# UNITED STATES PATENT AND TRADEMARK OFFICE

APPLICATION NO.	FILING DATE	FIRST NAMED INVENTOR	ATTORNEY DOCKET NO.	CONFIRMATION NO.
10/528,215	03/17/2005	Bernd Salomon-Bahls	11138-017	6269
757 7590 09/28/2007 BRINKS HOFER GILSON & LIONE P.O. BOX 10395 CHICAGO, IL 60610			EXAMINER KEE, FANNIE C	
			ART UNIT 3679	PAPER NUMBER
			MAIL DATE 09/28/2007	DELIVERY MODE PAPER

# Office Action Summary

## **DETAILED ACTION**

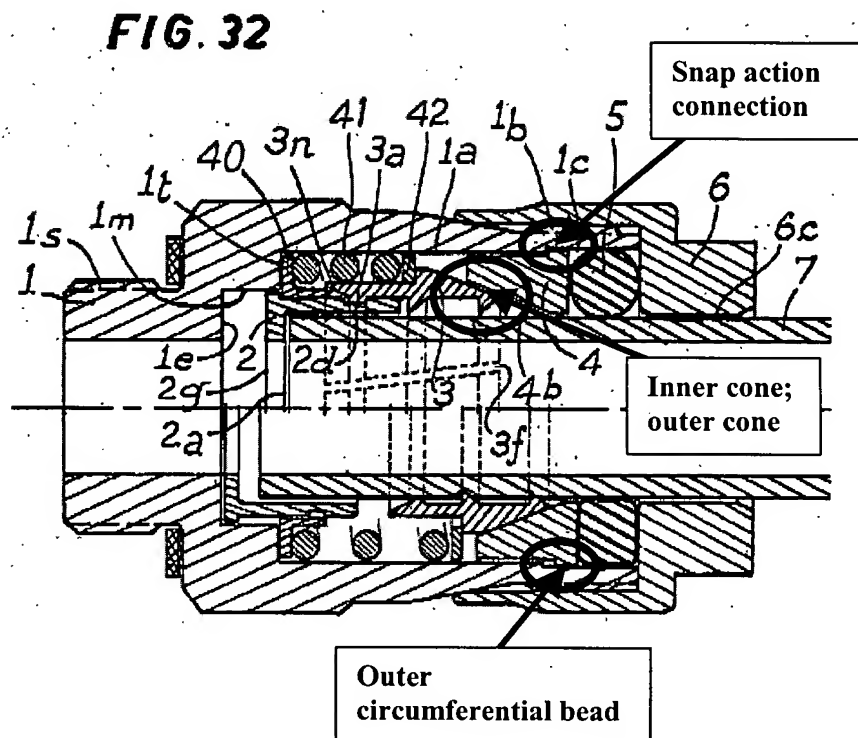
With regard to claim 1, and as seen in Figure 32 below, Legris discloses a connecting device for the plug-in connection of at least one pipeline (7), comprising a housing part (1, 4) having at least one receiving opening (1a) for the insertion of the pipeline, and a clamping ring (3), which is arranged in the receiving opening and, in order to lock the pipeline in place, interacts with an inner cone of the housing part, the housing part being made in two parts from a base part (1) and an insert part (4), which is connected to the base part via a snap-action form-fitting connection and which has the inner cone and a dirt seal (5) for resting on the circumference of the inserted pipeline.

Legrís does not disclose that the insert part is formed of a first, relatively hard and dimensionally stable plastic material or that the dirt seal is formed of a second, relatively soft and elastic plastic material, or is molded directly onto the insert part as a single piece with a cohesive material joint therebetween. However, it is well known in the art to mold a seal directly onto an insert part as a one piece construction so that the seal cannot be dislodged from the insert part and more firmly secures against leaks as a pipeline is inserted into the opening and into the insert part.

It would have been obvious to one of ordinary skill in the art at the time the invention was made to have fabricated the insert part from plastic and the dirt seal from an elastic plastic material different from that of the insert part because it has been held to be within the general skill of a worker in the art to select a known material on the basis of its suitability for the intended use as a matter of obvious design choice (In re Leshin, 125 USPQ 416) and to have molded the dirt seal directly onto the insert part as a one piece construction so that the seal

With regard to claim 2, and as seen in Figure 32 above, Legris discloses the insert part being of sleeve-shaped design and being insertable into a widened portion of the receiving opening of the base part in a manner providing a circumferential seal against the penetration of

dirt and similar foreign bodies, the insert part lying completely within the base part and ending flush with the receiving opening when the insert part is positioned in the receiving opening.

With regard to claim 6, and as seen in Figure 32 above, Legris discloses a supporting sleeve (2) arranged within the base part for the frictional engagement of the inserted pipeline.

With regard to claim 7, and as seen in Figure 32 above, Legris discloses wherein the housing can be connected to a further assembly part via at least one connecting section (1s).

With regard to claim 8, and as seen in Figure 32 above, Legris discloses the connecting section being designed as a pipe attachment for insertion into a second receiving opening.

With regard to claim 9, and as seen in Figure 32 above, Legris discloses the claimed invention but does not disclose the base part being formed of two regions of two different types of molded plastic material.

However, it would have been obvious to one of ordinary skill in the art at the time the invention was made to have formed the base part of two regions of two different types of plastic because it has been held to be within the general skill of a worker in the art to select a known material on the basis of its suitability for the intended use as a matter of obvious design choice.

With regard to claim 10, and as seen in Figure 32 above, Legris discloses the connecting section being designed as a screw thread attachment (1s, column 10, line 36) including an externally threaded connector.

With regard to claim 16, and as seen in Figure 32 above, Legris discloses that the insert part can be inserted into the base part with a press fit and has an outer circumferential bead.

With regard to claim 17, and as seen in Figure 32 above, Legris discloses the circumferential sealing bead being attached to the insert part to form a single piece but does not disclose that the circumferential sealing bead consists of an elastic material.

However, it would have been obvious to one of ordinary skill in the art at the time the invention was made to have fabricated the circumferential sealing bead from elastic because it has been held to be within the general skill of a worker in the art to select a known material on the basis of its suitability for the intended use as a matter of obvious design choice. In re Leshin, 125 USPQ 416.
